SCOLMORE

MinIGrid Plates

APPROVAL SHEET

A102

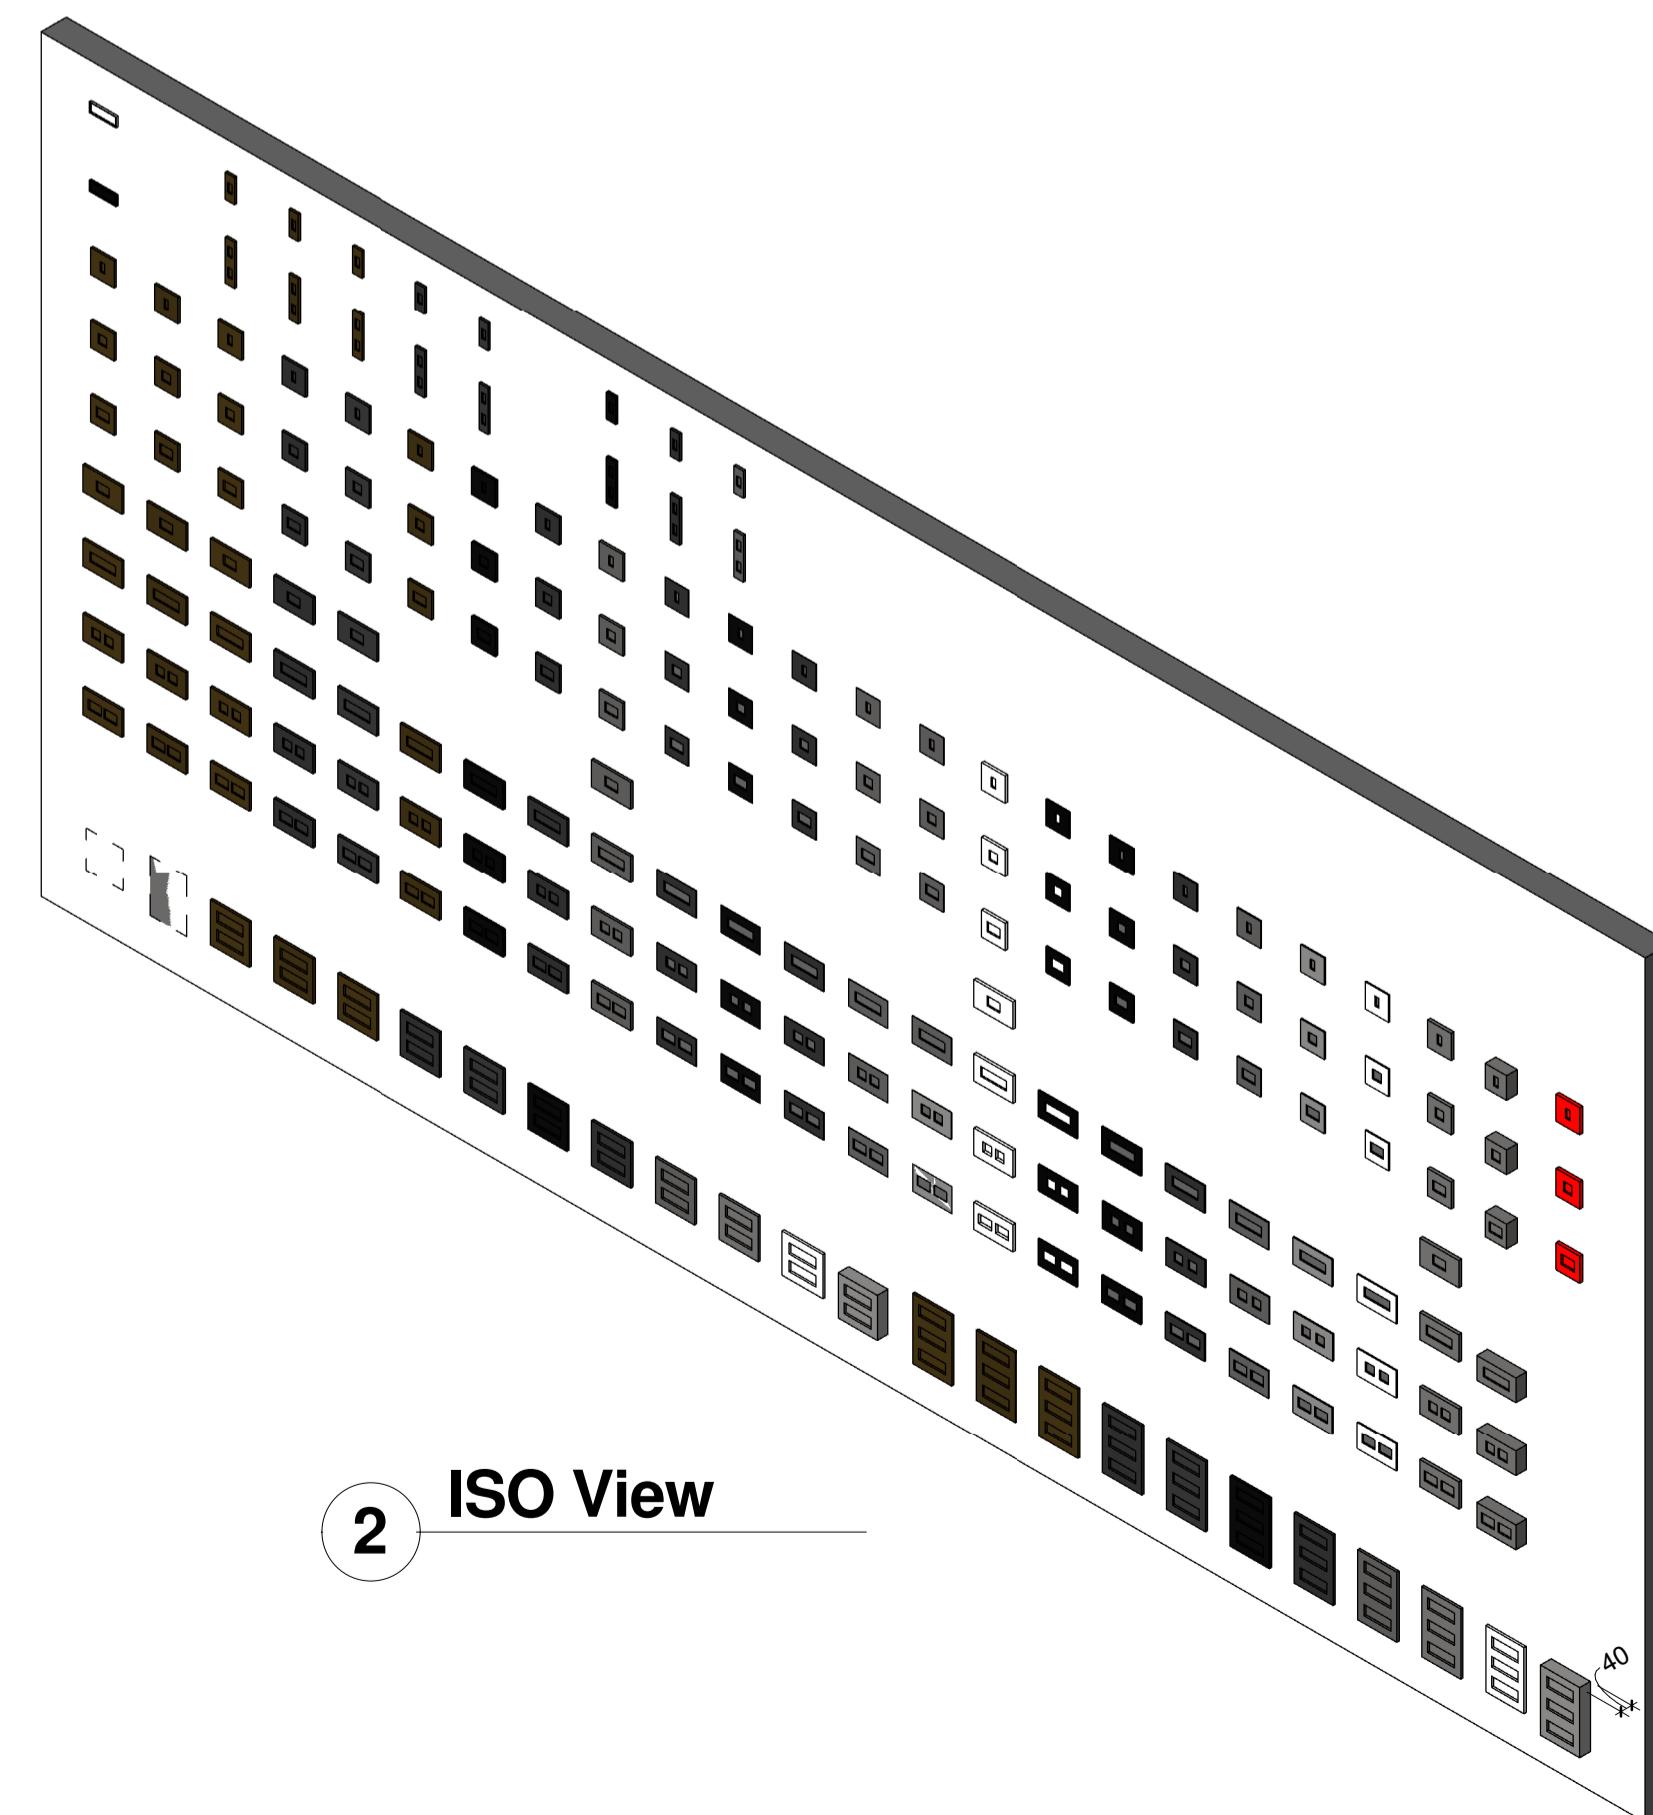
1. Mark 25 Description Updated to '2 Gang Double Row K/O Box 47mm Deep'.
2. Mark 26 Description Updated to '2 Gang Triple Row K/O Box 47mm Deep'.
3. Mark numbers 32, 41, 50, 59, 68, 77, 155, 160, 165, 173, 175, 180, Model numbers corrected.
4. Mark number 147 Type description updated to 'With Black (BK) or White (WH) Inserts. Specify with Definity Cover plate'
5. Mark numbers 86, 87, 88, 95 and 104 omitted.
